Product Change Notification

Date Issued :	February 22, 2023	PCN Number :	513330
Reason for Change :	Packaging Method/Quantity Changing		
Description of Change :	This notification is to inform you about part(s) listed will undergo changes for packaging size/ packaging specification change. No changes will be made to product as part of this change.		
Reason for Short Notice :	Special Request		
Assessment of Change :	No change to parts - Form/Fit/Function		
Planned Implementation Date :	May 22, 2023		
Sample Availability Date:	February 28, 2023		
Internal Molex Qualification Date :	February 28, 2023		
Last date to request Samples by Customer :	March 31, 2023

2156740051 Revision A

Before Picture

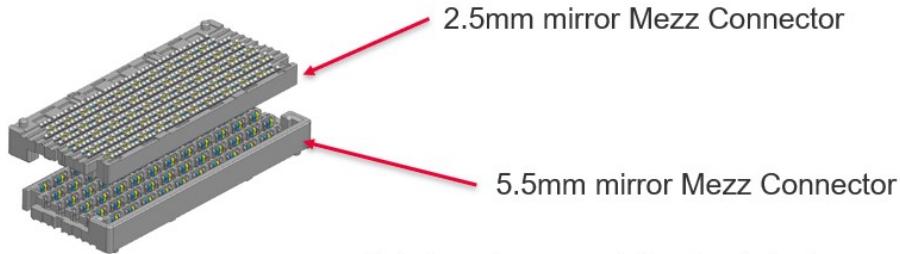
- The Minimum Line/Delivery Quantity (MLQ/MDQ) has increased for Mirror Mezz connector

Before
MLQ/MDQ:1xSPQ

After
MLQ/MDQ:4xSPQ
